Case No. 14-F-0490

**PETITION OF CASSADAGA WIND, LLC FOR AN AMENDMENT TO
THE CERTIFICATE OF ENVIRONMENTAL COMPATIBILITY & PUBLIC NEED FOR
THE CASSADAGA WIND PROJECT**

Reference: Cassadaga Wind Project – Change to the POI substation location
Case No. 14-F-0490

Figure 1. POI Substation Layout Comparison: A10 Certified Layout and Current Layout

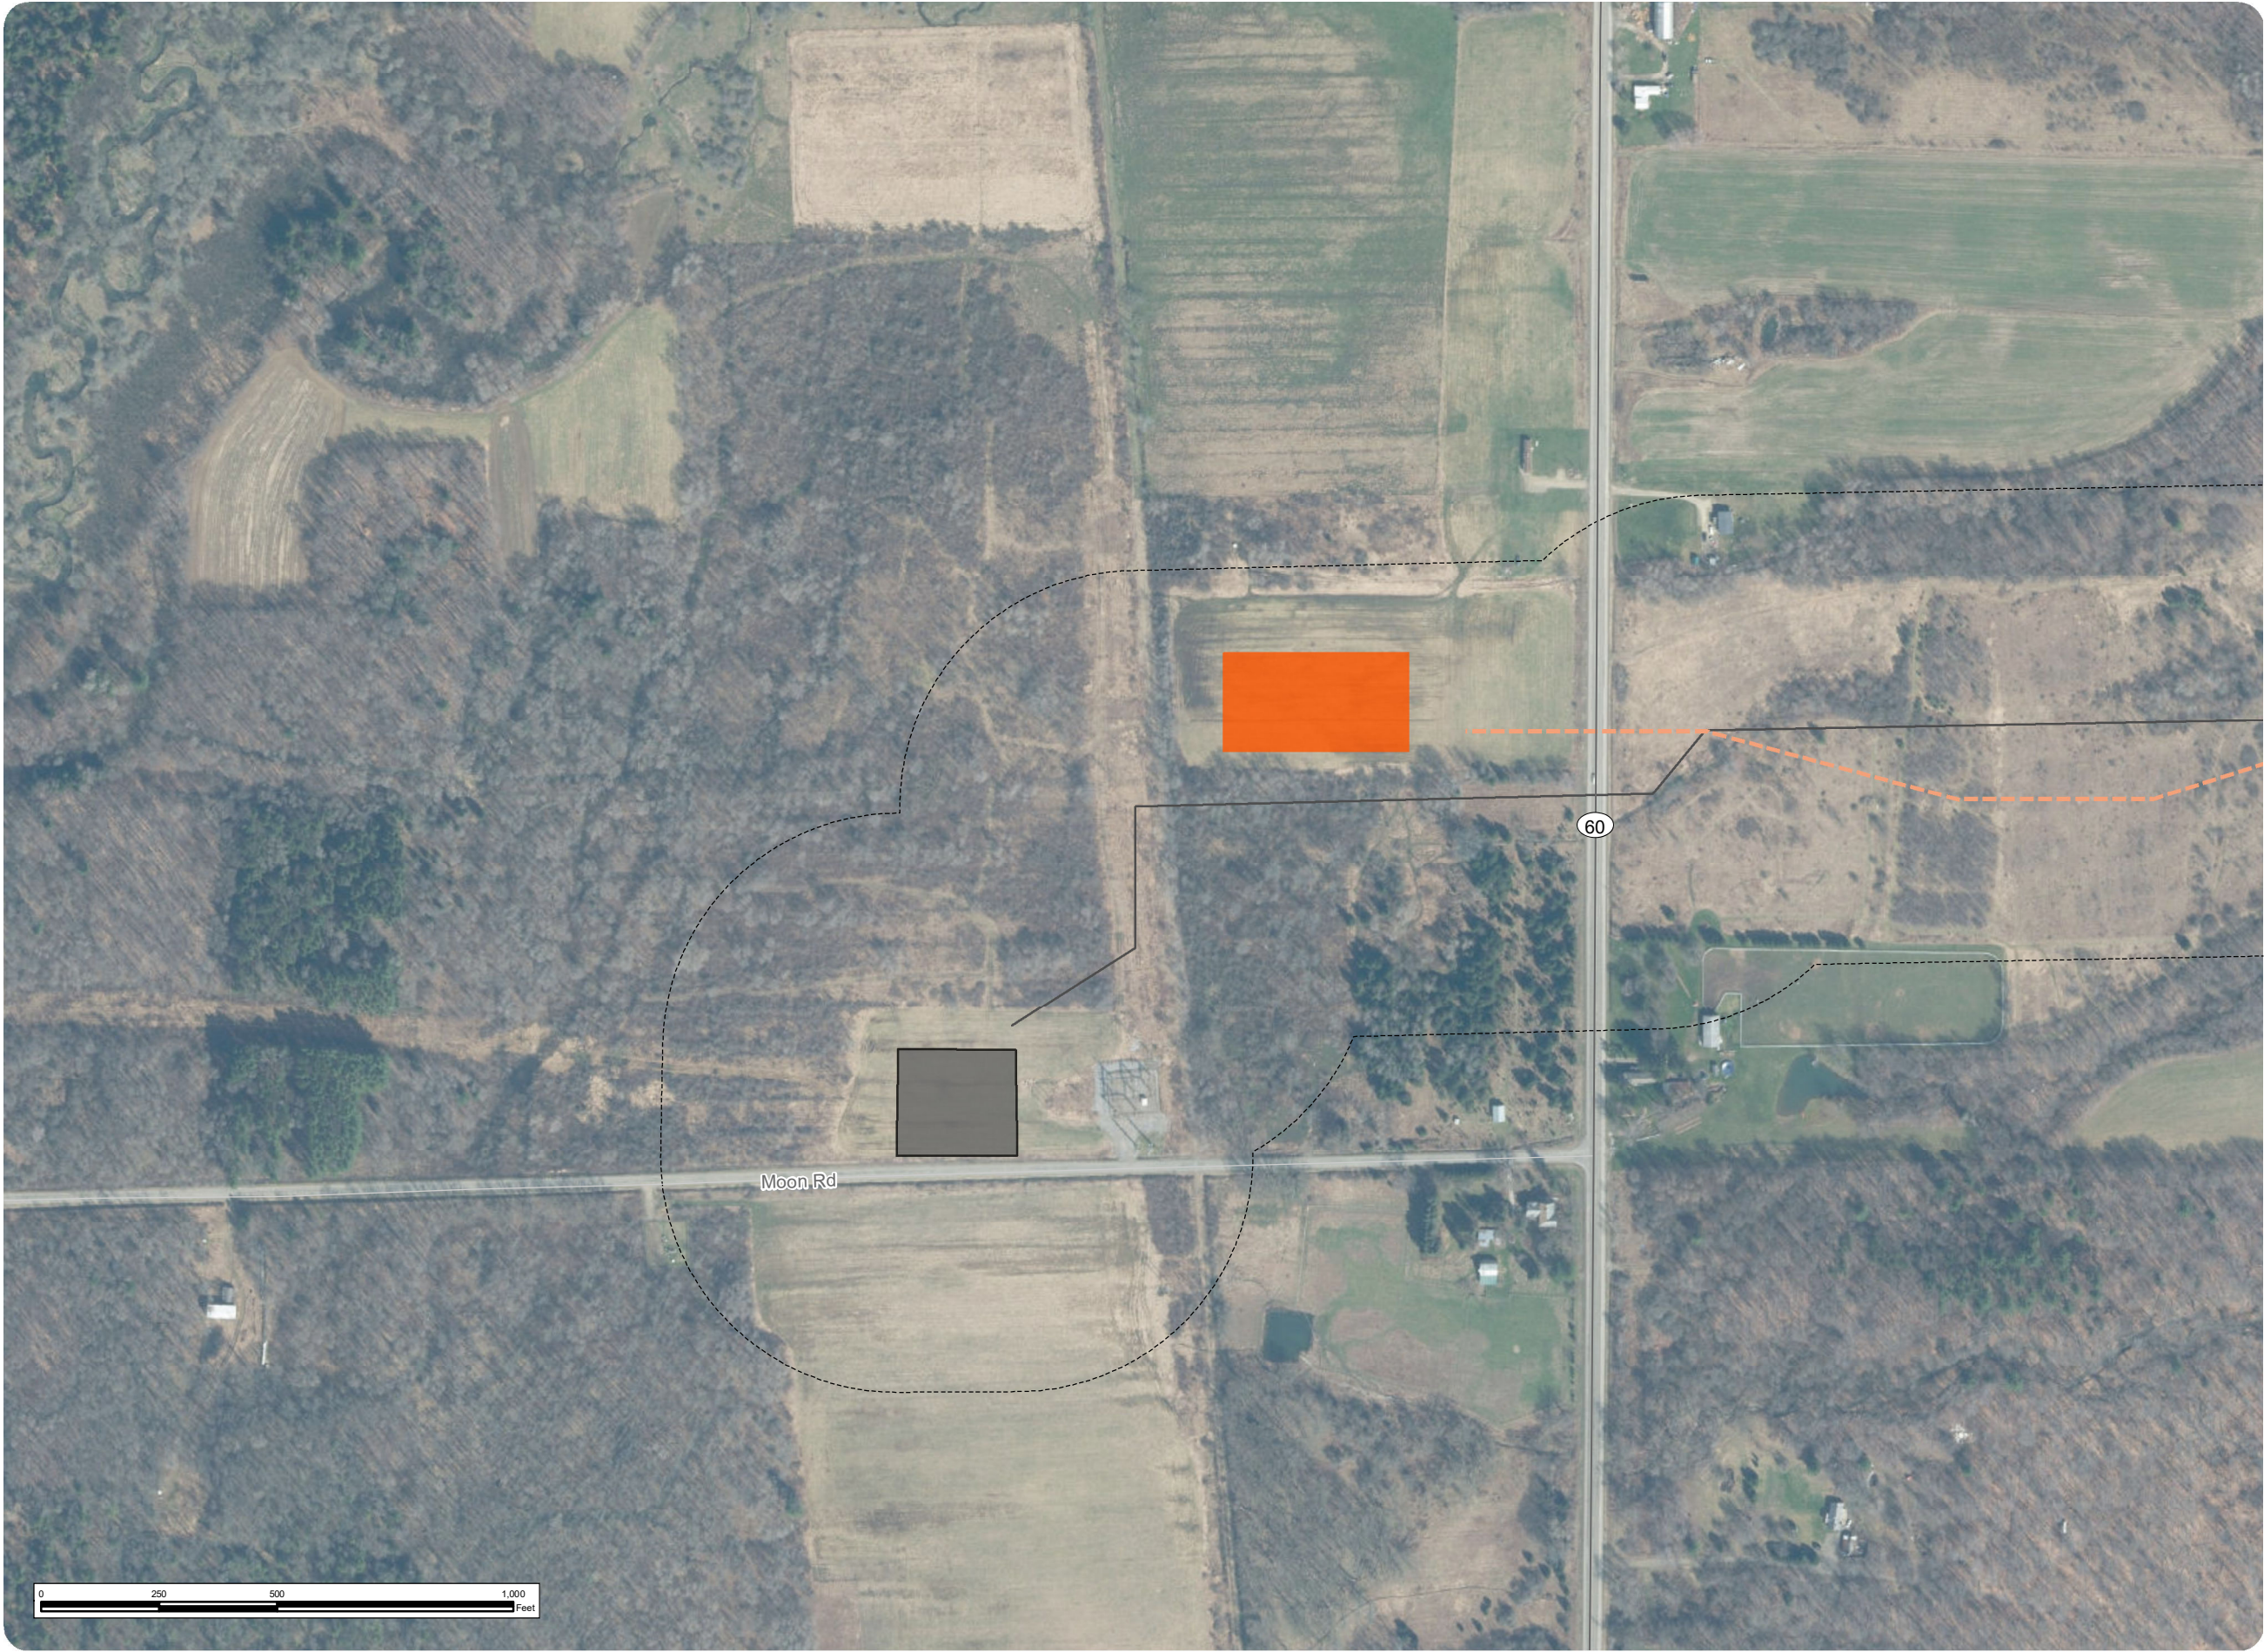
Environmental Design & Research, Landscape Architecture, Engineering, & Environmental Services, D.P.C. (EDR) has prepared this memorandum to summarize changes to the Cassadaga Wind Project (the “Facility”). Specifically, this memorandum addresses the proposed re-location of the Point of Interconnect (“POI”) substation from the site approved in the Certificate of Environmental Compatibility and Public Need (“Certificate”) issued to Cassadaga Wind LLC (the “Certificate Holder”) on January 17, 2018 by the New York State Board on Electric Generation Siting and the Environment (“Siting Board”). Subsequent to receiving the Certificate, Niagara Mohawk Power Corporation d/b/a National Grid (hereinafter referred to as “National Grid”) provided additional line relocations that would need to be completed in order to build the Certified POI substation. As explained below, National Grid’s required design changes presented several problems with the use of the site identified in the Article 10 Application (hereinafter referred to as the “Certified POI substation”). The move proposed by the Certificate Holder addresses this issues and other concerns raised by National Grid regarding the original location of the Certified POI substation. Please refer to Figure 1 of this memorandum for a general depiction of the proposed POI substation change.

The POI substation is required to interconnect the Facility to the New York State electric transmission system. In the Article 10 Application the POI substation was proposed to be located immediately adjacent to National Grid’s Dunkirk-Moon 115 kV transmission line and an existing switching station (the Moon Switching Station), on the north side of Moon Road in the Town of Stockton. The POI substation location proposed in the Article 10 Application was originally selected for its proximity to the existing Moon Road Substation and other proposed Facility components. In addition,

As a result of these design challenges and based on consultation with National Grid and the NYISO, the Certificate Holder is now proposing to construct the POI substation (hereinafter referred to as the “proposed POI substation”) on an adjacent parcel located approximately 700 feet northeast of the existing Moon Switching Station (See Figure 2, Sheet 4). It should be noted that while the POI has shifted more than 500 feet, the proposed site is located wholly within the corridor reviewed for the Certified transmission line. As described above, the now proposed POI substation site is sited on land owned by the same landowner that owns the Certified POI substation location, and that landowner is supportive of development of the substation on this new proposed site and the Certificate Holder has executed an option to purchase agreement with the landowner for the new proposed location. Both the Certified POI substation and the proposed POI substation are sited on a mix of active and fallow agricultural land (hay fields). The field where the proposed POI substation is planned is flat and easily accessed from Route 60. In addition, it is directly adjacent to the proposed generator lead line and the existing National Grid transmission lines, which significantly reduces the number of poles, access roads, and forested wetland clearing that would otherwise occur at the Certified POI substation location based on National Grid’s design requirements. The location also avoids the need to cross the existing National

Figure 1: Revised Facility Layout

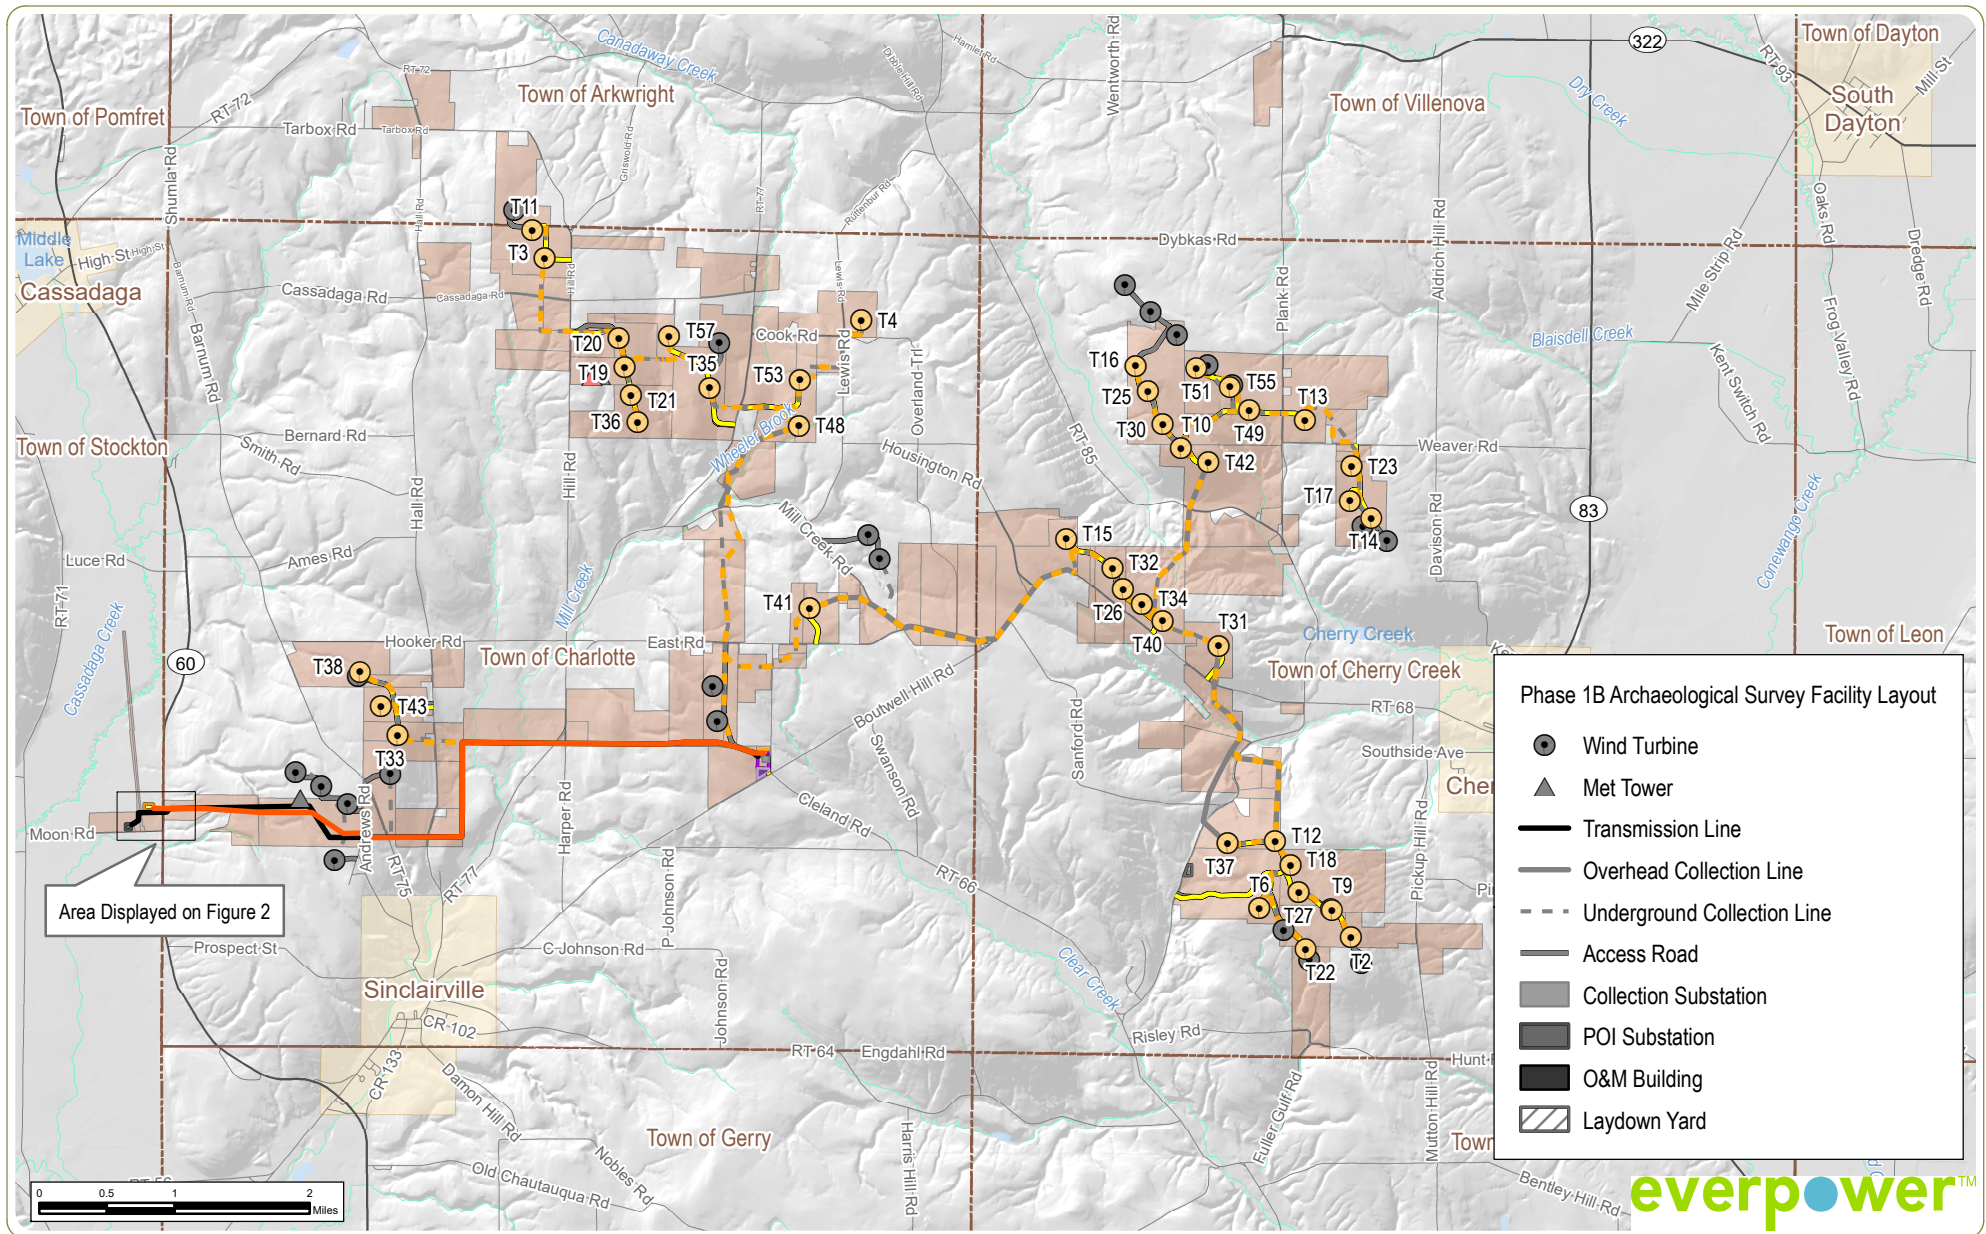
Environmental Design & Research, Landscape Architecture, Engineering, & Environmental Services, D.P.C. (EDR) is assisting Cassadaga Wind, LLC, a subsidiary of Innogy Renewables US LLC (the Applicant), with environmental permitting for the Cassadaga Wind Project (the Facility). Following the most recent correspondence with the New York State Office of Parks Recreation and Historic Preservation/State Historic Preservation Office (NYSOPRHP/SHPO) regarding the Facility, there has been a minor layout shift, which is summarized below. The purpose of this memorandum is to provide documentation to SHPO describing this layout shift and requesting confirmation that this minor layout change does not require additional archaeological testing.

Figure 2: Revised POI Substation Location

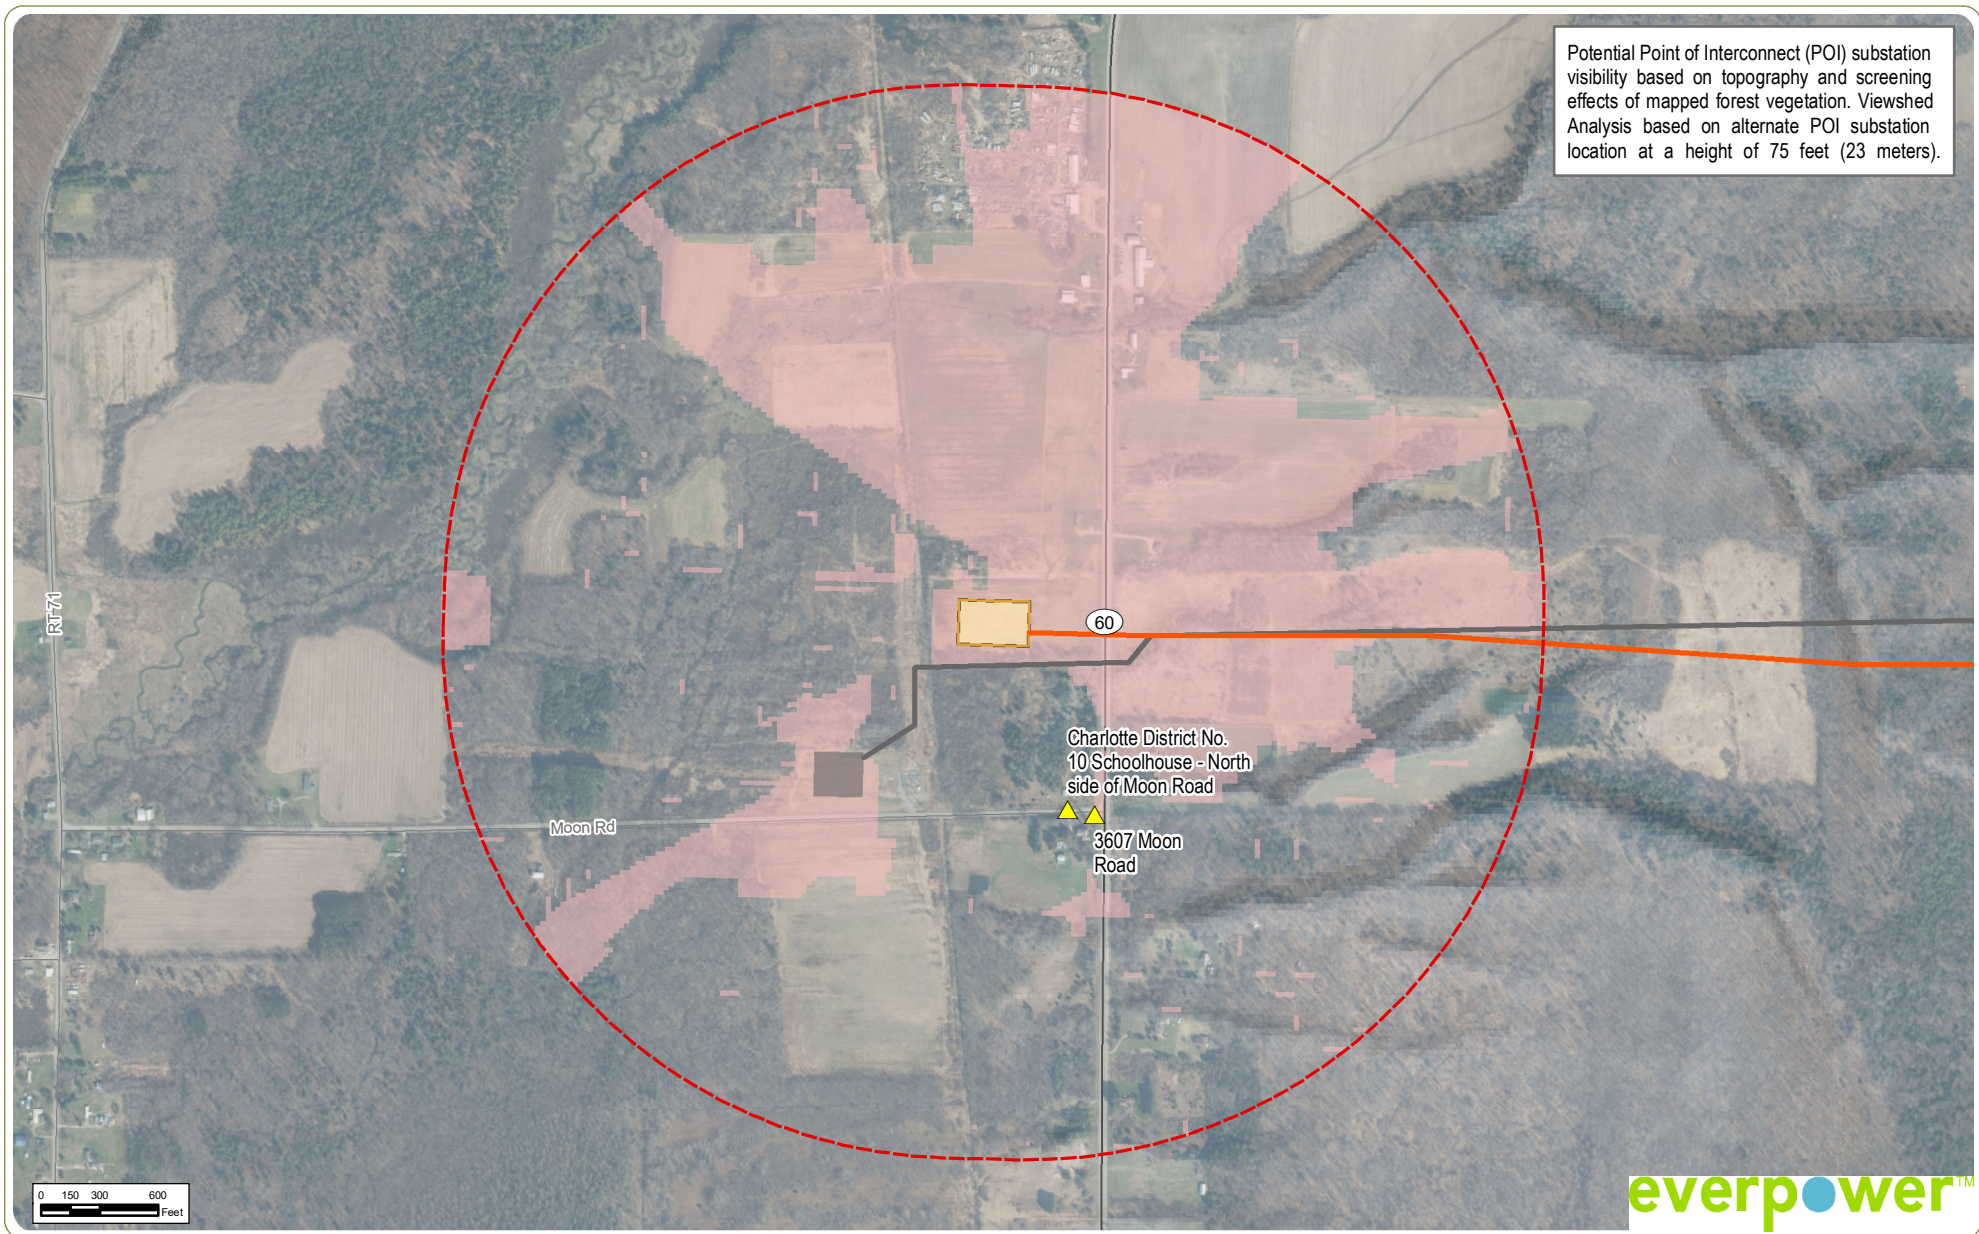
Most recently, subsequent to the Article 10 review, a National Grid Facilities Study addressing the POI Substation required a substation design that presented several significant problems associated with the use of this site, consisting of additional filling and clearing within an adjacent forested wetland. Therefore, as a result of these problems, the Applicant, in consultation with National Grid and the New York Independent System Operator, examined alternate POI locations in the area and ultimately selected the one depicted in the attached Figures 1 and 2 as posing the fewest environmental impacts. The current Facility layout is located in areas that were included in the layout evaluated in the Phase 1B report, with the exception of the POI substation and a small portion of overhead transmission line connected to the substation (see attached Figure 1). As discussed above these components were shifted slightly to minimize wetland impacts. The POI substation, located within the Town of Stockton, was originally proposed to be located immediately adjacent to National Grid's existing Dunkirk-Moon 115 kV transmission line, on the north side of Moon Road. It will now be located approximately 1,000 feet northeast of its previously proposed location, on the west side of State Route 60 (see attached Figure 2). These new areas were not shovel tested during EDR's Phase 1B archaeological survey.

Based on this review, the SHPO concurs that additional archaeological testing as a result of the revised Facility layout is not warranted and we continue to recommend that this undertaking will have an Adverse Effect on historic properties due to the introduction of modern elements into the rural landscape that serves as the setting for these properties.
